To	Ben Fryer	From	Matt Rowbotham
Fax No		Date	12/12/07
Company	Doug Gow and Associates	Reference	Preliminary Geotechnical Assessment Workshop Letter
cc		Page	1 of
Subject	Preliminary Geotechnical Assessment - The Lakes Estate Stages 1.2 to 9.2

Outlined below is a summary of the geotechnical issues which will need consideration for final design and development at the new release of land for The Lakes Estate (Stages 1.2 to 9.2). It is hoped that this preliminary information is helpful for your initial discussions. If you have any questions, please contact Matt Rowbotham or Iain Turner at our Coffs Harbour Office.

client:	DOUG GOW AND ASSOCIATES PTY LTD
project:	THE LAKES ESTATE STAGES 1.2 TO 9.2
title:	HOUSING NOT RECOMMENDED IN WATERCOURSES
project no:	GEOTCOFH02233AA
figure no:	FIGURE

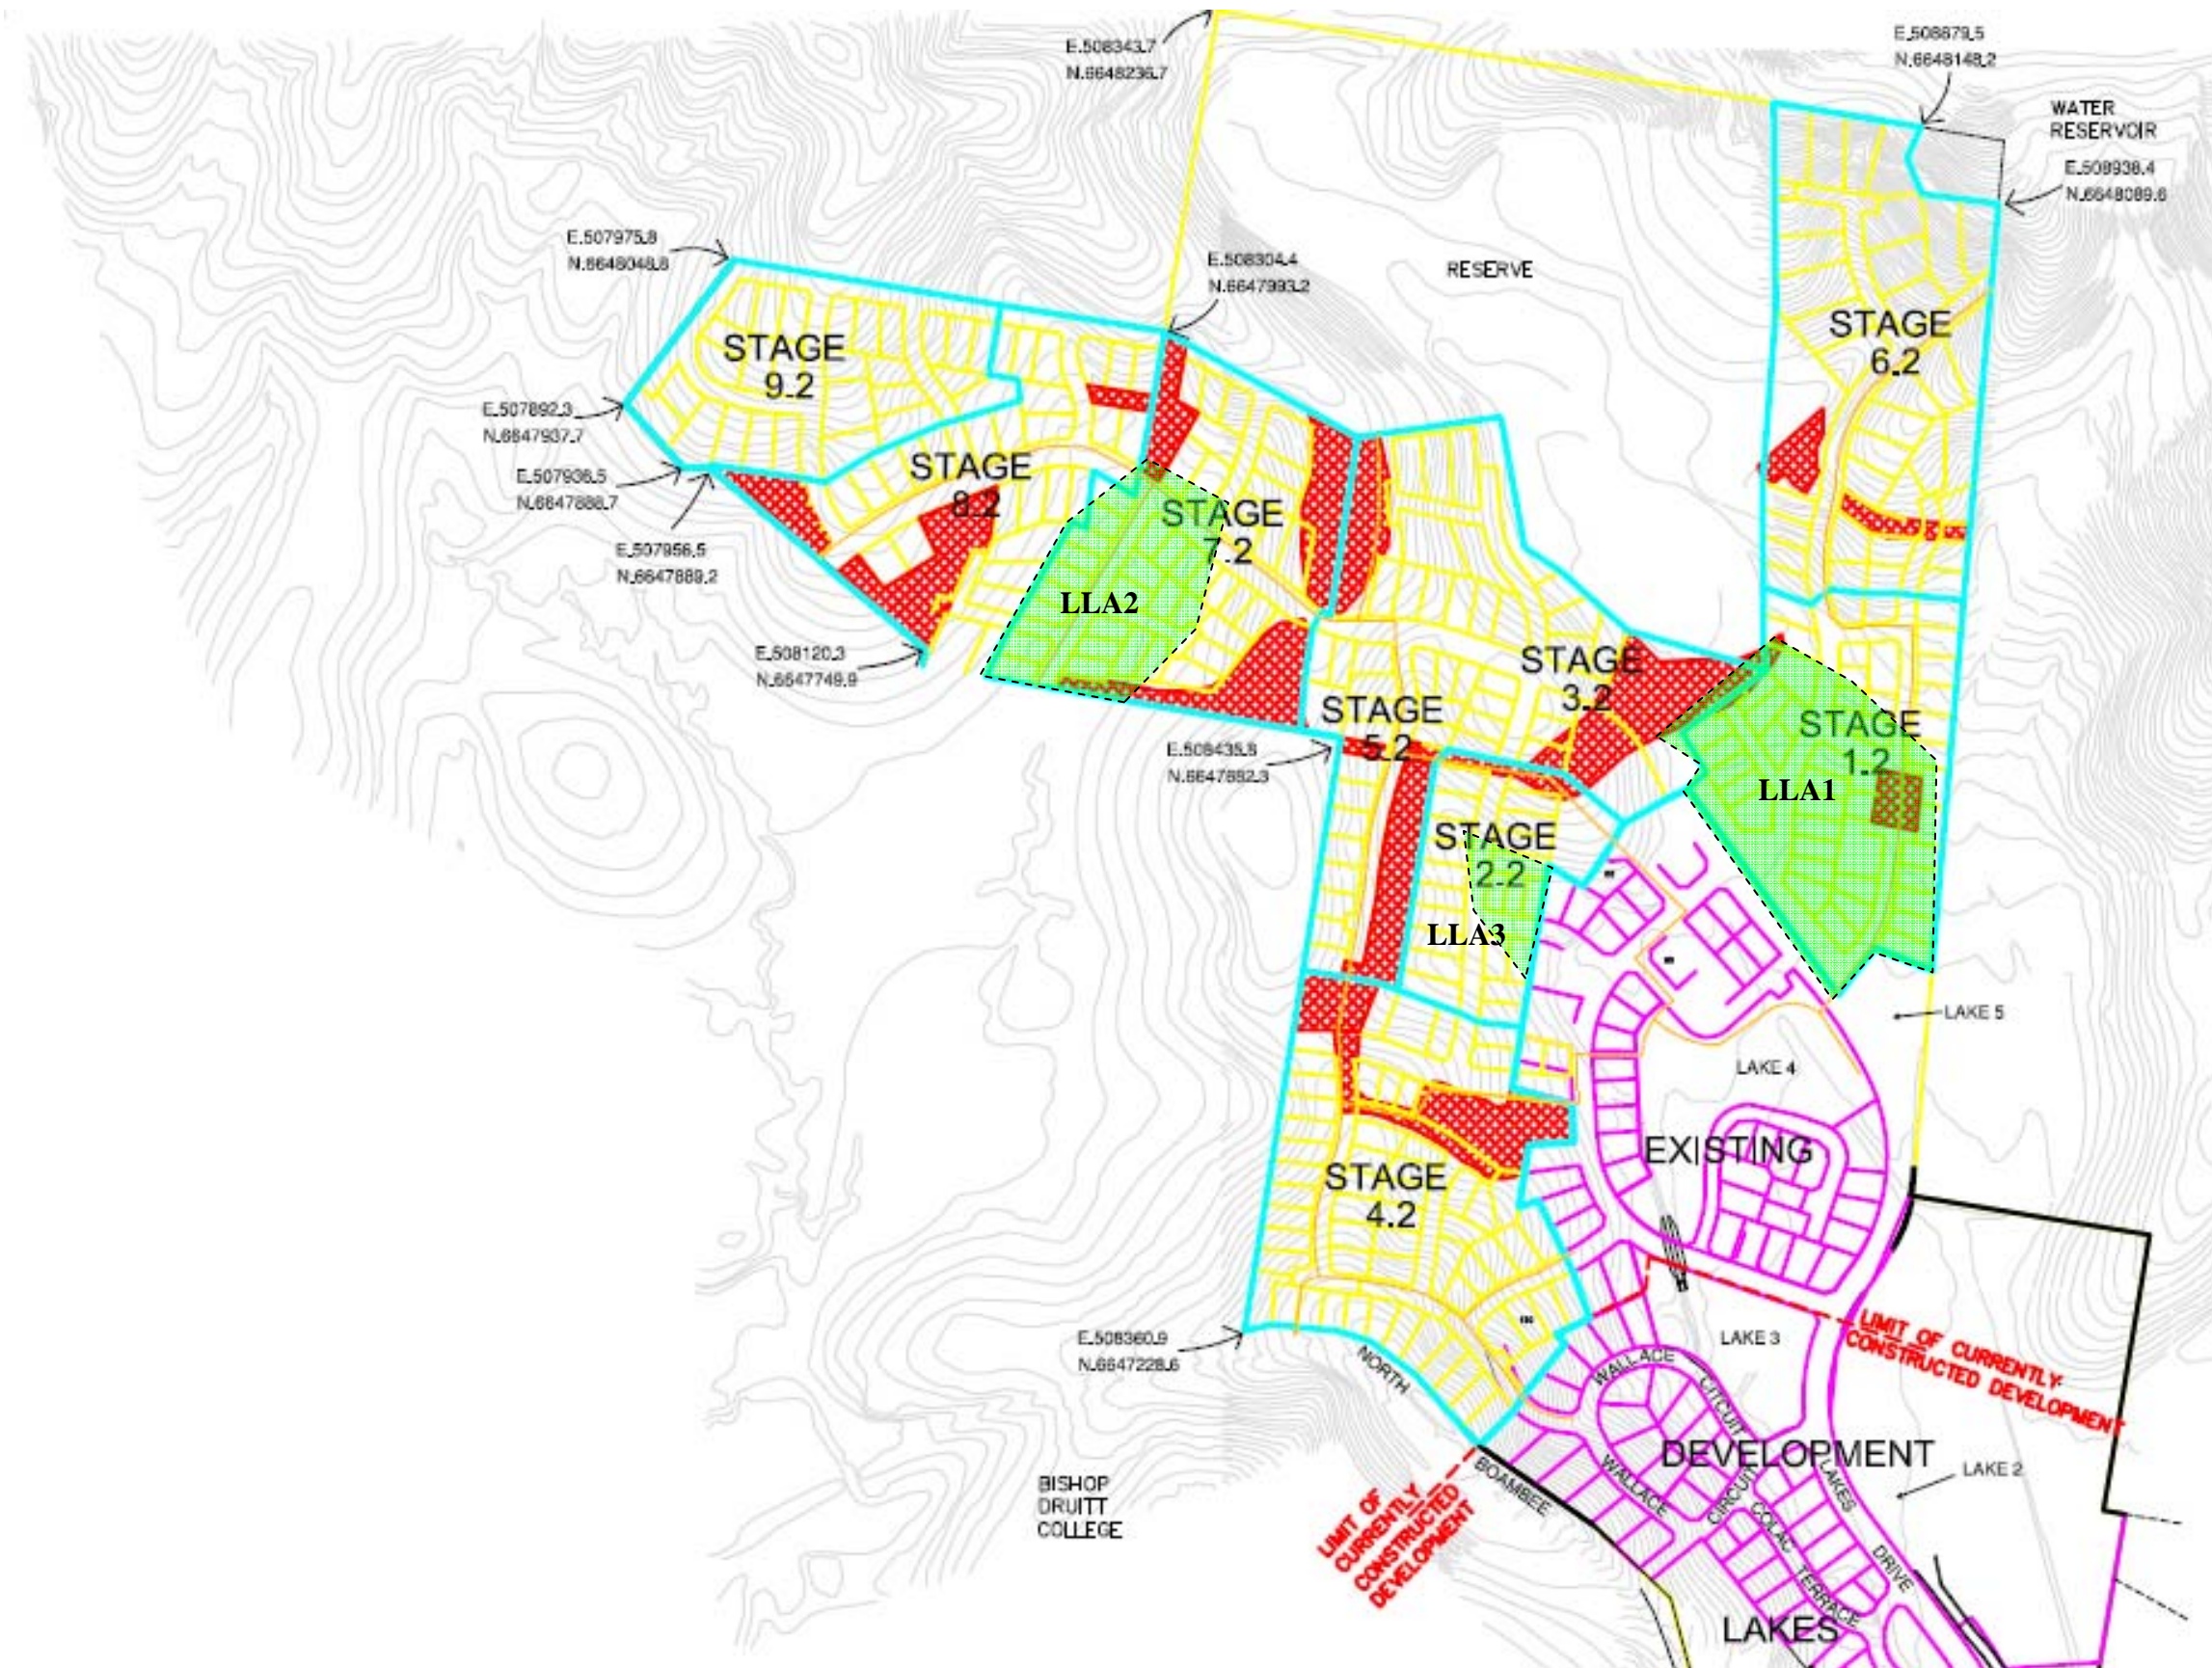
Some housing plots are shown within axes of watercourses where compressible subsoils are expected and extreme runoff (surface water) frequently occurs. A plan of such affected areas is attached.

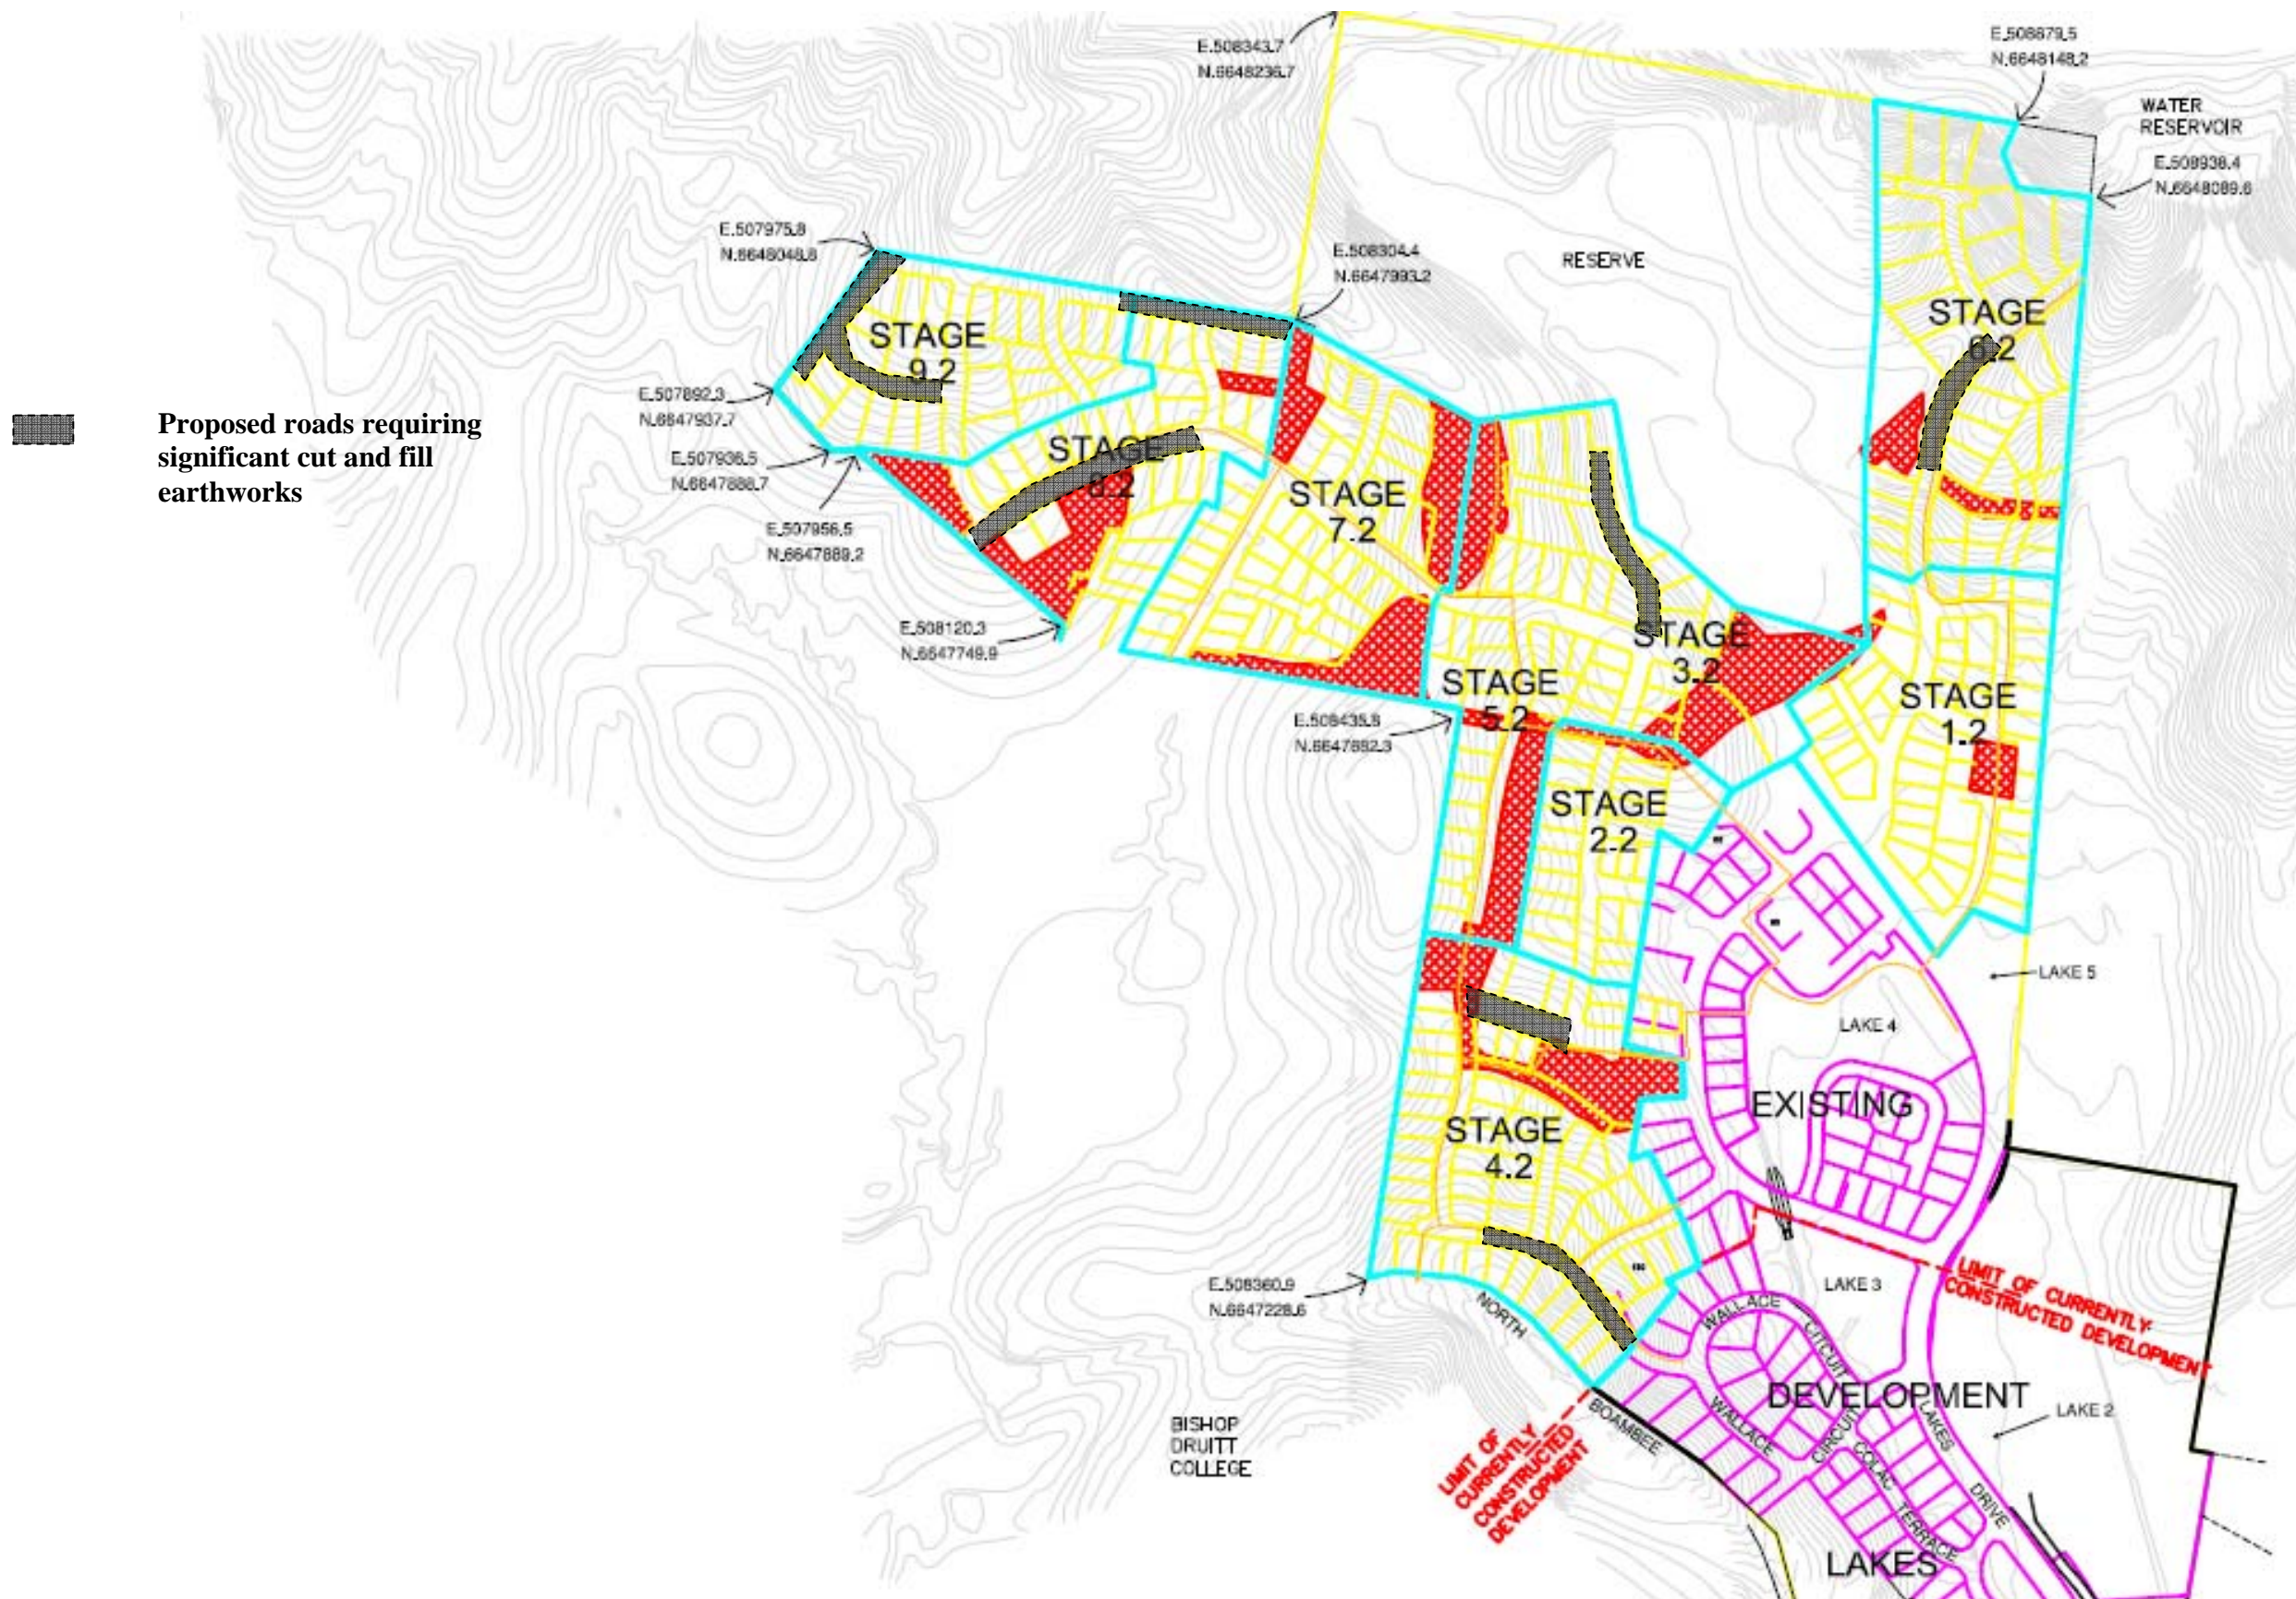
Three low lying areas were identified during the investigation which may present difficulties during construction, Low Lying Area 1 (LLA1), LLA2 and LLA3 indicated on the plans provided.

LLA1 is located adjacent and nearby to the land currently under earthworks construction at The Lakes Estate. LLA1 is located in Stage 1.2.

Investigation undertaken in this area was principally aimed at acid sulphate soil assessment. Test pits indicated shallow groundwater, soft to firm clay soil and significant lenses of silt. Based on our experience with the adjacent earthworks and being typical of silt, the subsurface conditions and shallow water level together are likely to present difficulties. Compaction of wet fine grained soils and problems with traffickability have been encountered. To allow construction to proceed in this area, improved drainage will be needed. Importation and compaction of granular fill (e.g. quarried rock fill) will likely be required to allow a relatively rigid working platform to be placed that will enable placement of fill to achieve filling to a required standard for the support of structures (e.g. 'level 1' in accordance with AS3798-2007).

Further to the above it is likely that significant portions of the silt and soft to firm clay will require over excavation and removal prior to placement and compaction of the quarried fill. Care must be taken to avoid excavation below the water table in silt.

LLA2 is located between Stage 7.2 and Stage 8.2 in the axis of the valley. From the test pit investigation subsurface conditions are known to comprise moist to wet and firm to stiff 'hillwash' clay extending to some 1m depth overlying stiff to very stiff clay. Within the upper 1m groundwater seepage was observed.

Based on the plans provided, an access road and residential lots are to be located in this area. Similar to LLA1 improved drainage and the replacement of superficial clay with appropriately moisture conditioned clay fill or granular fill (rock fill) is likely to be needed.

LLA3 is located in Stage 2.2. Based on our earthworks experience in the adjacent stage it is likely that similar conditions will present to that of LLA1.
